STAFF RECOMMENDATION

NCPC File No. 6611

FEDERAL OFFICE BUILDING 8 BUILDING MODERNIZATION 200 C Street, SW Washington, DC

September 1, 2005

Rendering of North Facade

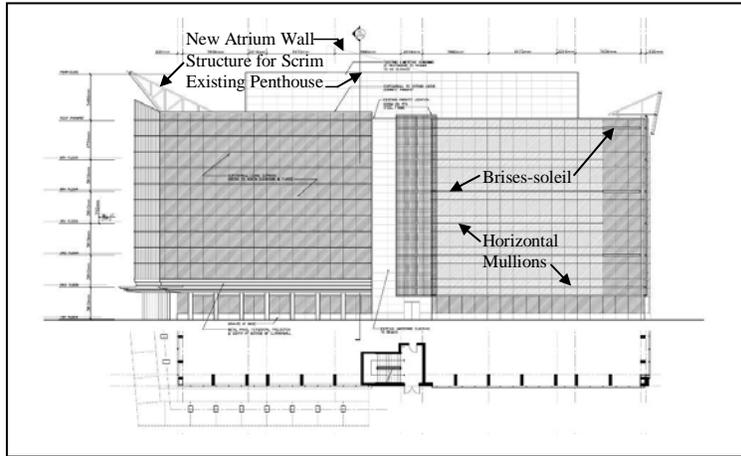
Staff Recommends that clear, untinted glass be used at the ground floor level to allow maximum visual access to the building interior, and that mirrored or highly reflective glass not be used at any level of the structure.

With several exceptions, the renderings provided give the impression that much of the building facade is a smooth continuous highly reflective or mirrored surface with little pattern to break down or indicate scale. Discrepancies exist between building elevations and renderings, which lack clarity of detail that staff expects will be refined in the preliminary site and building plans.

The current proposal calls for the use of clear glass to allow views into public spaces and at ground level storefront. Staff strongly supports this, since reflective glass reduces visual engagement and sense of scale at the pedestrian level. In fact, District zoning regulations, which GSA buildings are required to comply with to the maximum extent possible, were modified to define clear glass to ensure its use with the intent of allowing pedestrians to easily see into the preferred use spaces on ground floor commercial areas to facilitate ground-floor activity. Staff also recommends that the

Perimeter/Landscape Design – Plaza Plan

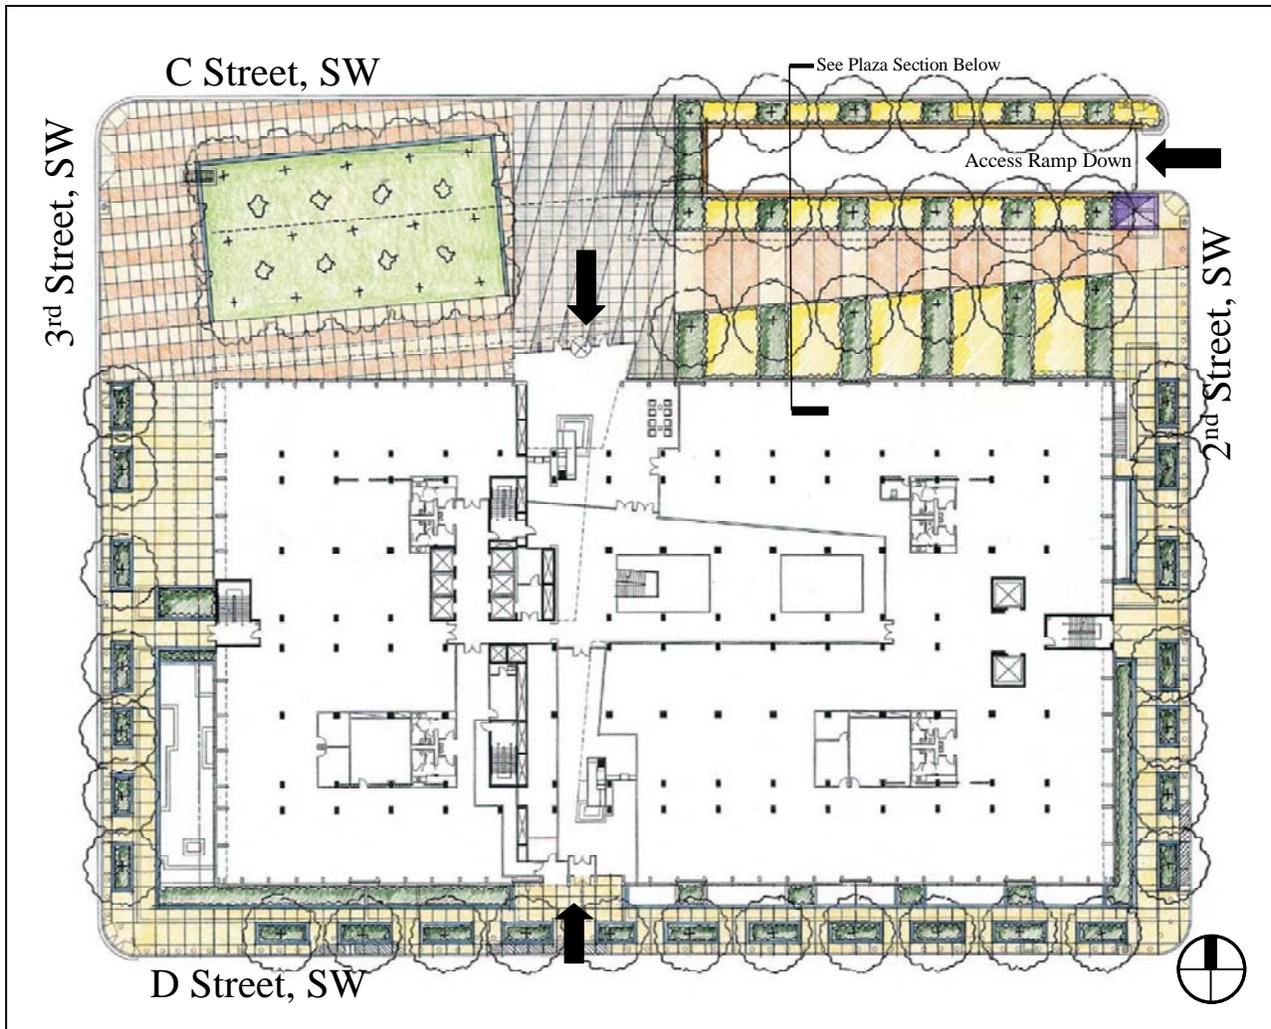
Information on perimeter security elements is insufficient for staff to comment on this time. Bollard placement in rendered plans and elevations is inconsistent, and no security elements are shown at the entry area on C Street. Staff urges GSA to further study and refine the perimeter security design on the three streets with limited setback, (2nd, 3rd and D Streets), by varying the use of the single planter element and introducing other elements of street furniture as encouraged in NCPC's Urban Design and Security Plan Objectives and Policies.

Staff understands that GSA has waited to design perimeter security at the plaza entrance in order to integrate public art into the plaza design and paving pattern before developing the remaining protection for the perimeter. Staff recommends further study to develop the design for submittal of preliminary site and building plans both for location and design of perimeter barriers and their interplay with sculpture, seatwalls and signage. Staff **recommends** that the applicant consult with staff in developing a concept for perimeter security that is integrated with the landscape, and **defers** comment on the landscape until more information on perimeter security is included.
